The Sewerage & Water Board OF NEW ORLEANS

Addendum No. 2

Your reference is directed to the Request for Quotation for **2023-SWB-79 – Saltwater Intrusion Emergency 2023 - Algiers Intake Mitigation (Rebid)** for the Sewerage and Water Board of New Orleans proposals that are due on **October 16, 2023, at 11:00 a.m. (CST)**.

ALGIERS TEMPORARY LAYDOWN AREA	
WORKING NUMBER: 18204	SHEET NUMBER: 13

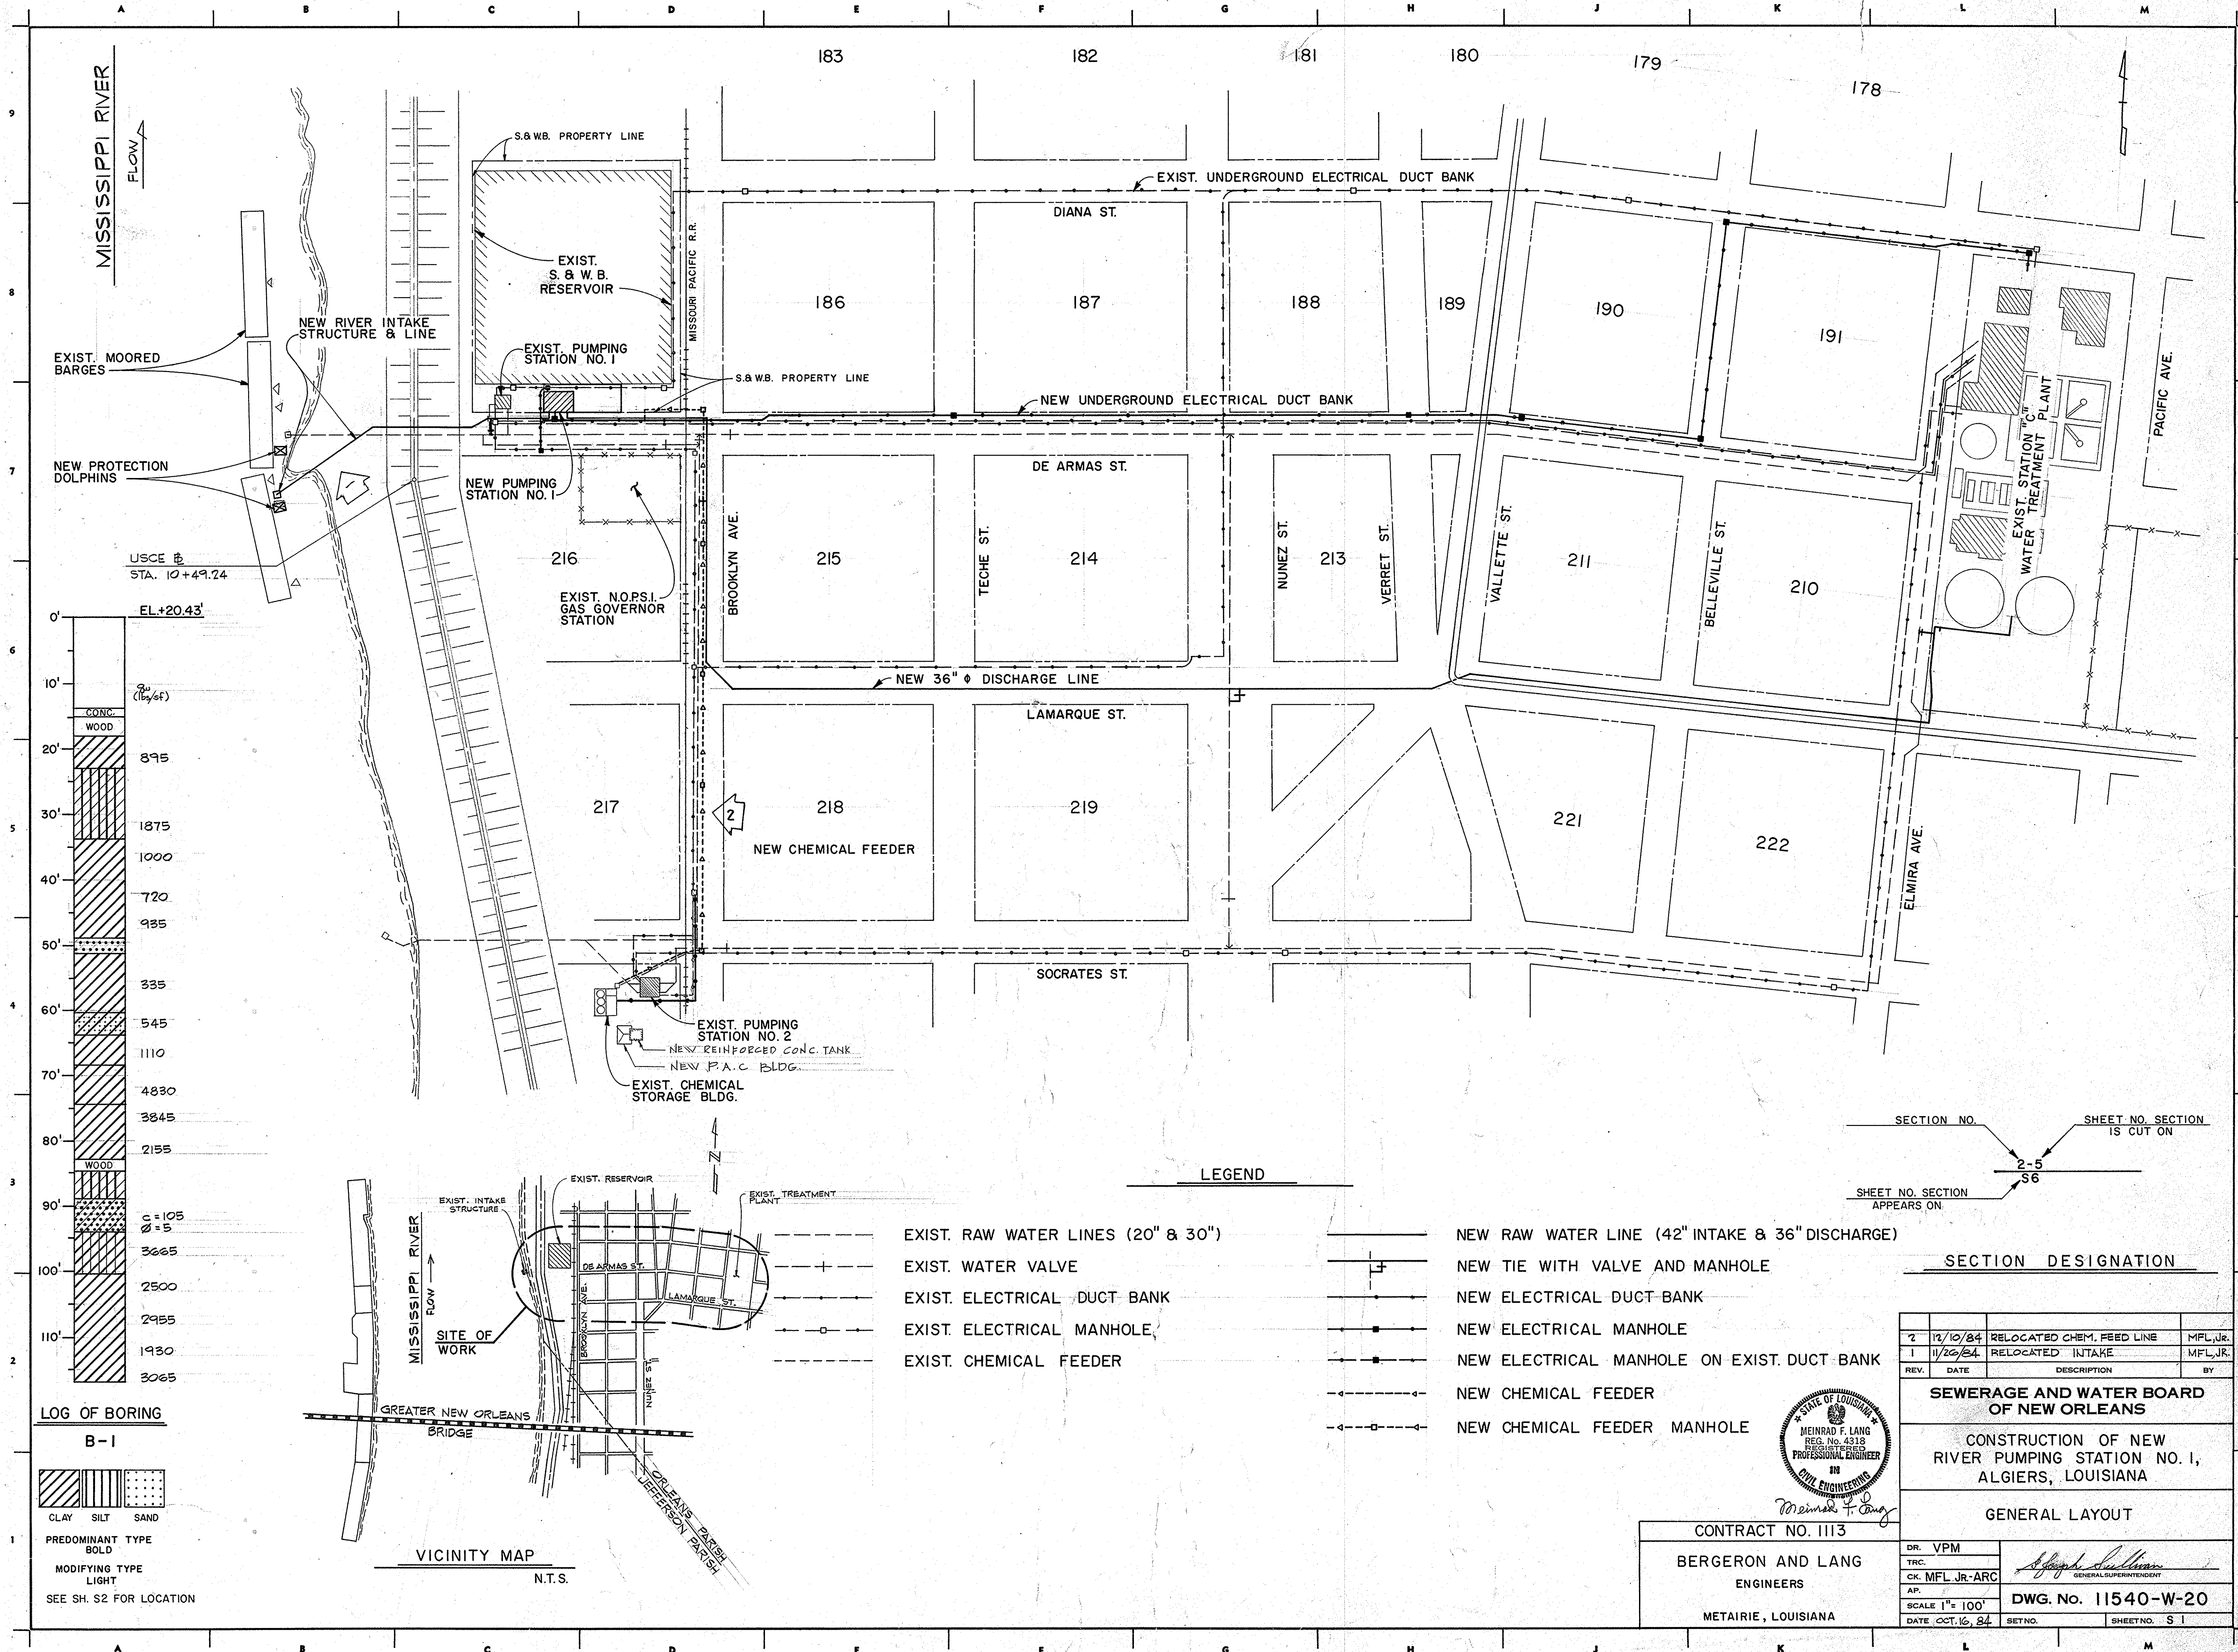
ADD Sheet 13 - Algiers Temporary Laydown Yard (Page 33)

- ALGIERS TEMPORARY LAYDOWN YARD – NOTES**
1. INSTALL NEW 9 FOOT CHAIN LINK FENCE ALONG BROOKLYN (ALGIERS INTAKE STATION TO DANA ST OFFSET 32 FEET FROM THE RIVER SIDE STEEL RAIL.
 2. INSTALL NEW 9 FOOT CHAIN LINK FENCE ALONG LEVEE OFFSET 30 FEET FROM THE TOE OF THE LEVEE.
 3. INSTALL CHAIN LINK GATES IN THREE LOCATIONS AS INDICATED.
 4. CONTRACTOR TO IMPORT 8" OF SAND FILL OF MISSISSIPPI RIVER PUMP SAND TO LEVEL SITE.
 5. CONTRACTOR SHALL PROVIDE LIGHTING, SECURITY, ETC TO MAINTAIN SITE 24/7 FOR DURATION OF EVENT.
 6. SEE RECORD DRAWING 11540-W-20 SHEET S10 FOR TYPICAL FENCING DETAILS
